CAMBRIDGE PLACE SUBDIVISION, PHASES 2-4

APPLICATION NUMBER 14 DATE March 7, 2013
APPLICANT Cambridge Place Subdivision, Phases 2-4
REQUEST Subdivision

DETAIL SITE PLAN

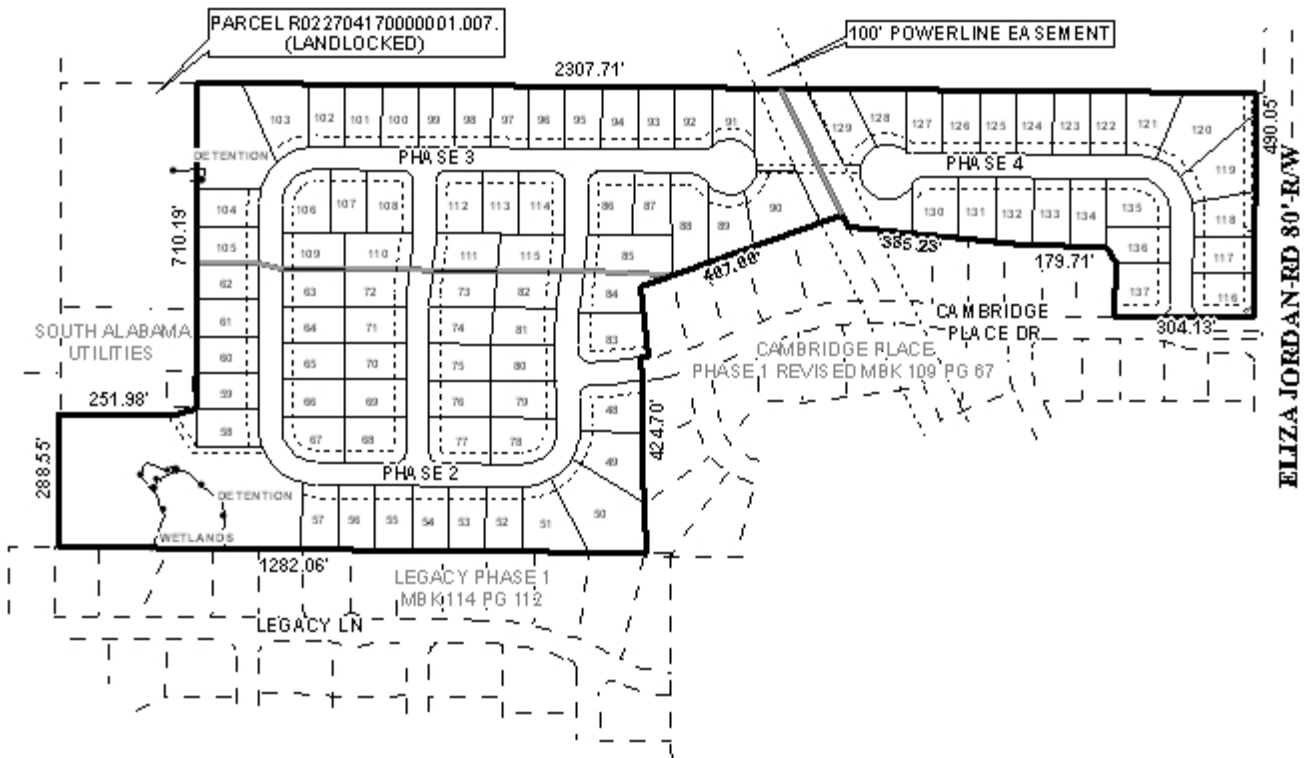
Proposed lots 116 through 120 have frontage along Eliza Jordan Road, a major street, with an illustrated right-of-way of 80'. As a major street, Eliza Jordan Road should have a 100' right-of-way, making dedication to provide 50' from the centerline of Eliza Jordan Road necessary. New roads are also proposed to be constructed and are illustrated as having 50' right-of-ways, which is sufficient for a minor street provided with curb and gutter. Two closed-end streets are proposed, one closed-end street is less than 600' long, while the other is 688' in length, both of which are illustrated as having a compliant 120' diameter cul-de-sac. Section V.B.6. of the Subdivision Regulations states that closed-end streets should not be longer than 600'. The two closed-end streets could be linked so as to eliminate the closed-end street that exceeds 600', as well as provide a second access point to the majority of the proposed lots in case of fire or other emergency. It should be noted that the proposed roadways will have to be built to City of Mobile standards and be accepted by Mobile County prior to the signing of the Final Plat.

There are detention areas shown on the preliminary plat as well as area that appears to be a common area, but are not labeled as such. If approved, all detention and common areas should be labeled as such, and a note should be placed on the Final Plat stating that the maintenance of all

As a mean of access management, a note should be placed on the Final Plat stating the lots 116 – 120 are denied direct access to Eliza Jordan Road, and all lots are limited to one curb cut each, with the size, design, and location of the curb cut to be approved by Mobile County Engineering and conform to AASHTO standards.

The 25’ minimum building setback from the proposed road is illustrated along all street frontages, on the preliminary plat, but is not labeled. The setback line should be retained and labeled on the Final Plat if approved.

1. revision of the plat to include the adjacent metes-and-bounds parcel previously illustrated as “reserved for sewer treatment plant” and provide frontage for the same parcel;
2. provision of additional mailing fees and labels;
3. revision of the plat to connect to currently proposed closed-end streets;

4. revision of the plat to illustrate dedication to provide 50' from the centerline on Eliza Jordan Road;
5. placement of a note labeling all detention facilities and common areas;

7. placement of a note stating that Lots 116-120 are denied direct access to Eliza Jordan Road;
8. placement of a note to comply with the City of Mobile storm water and flood control ordinances (*Must comply with the Mobile County Flood Damage Prevention Ordinance. Development shall be designed to comply with the storm water detention and drainage facility requirements of the City of Mobile storm water and flood control ordinances, and requiring submission of certification from a licensed engineer certifying that the design complies with the storm water detention and drainage facility requirements of the City of Mobile storm water and flood control ordinances prior to the issuance of any permits.*); and
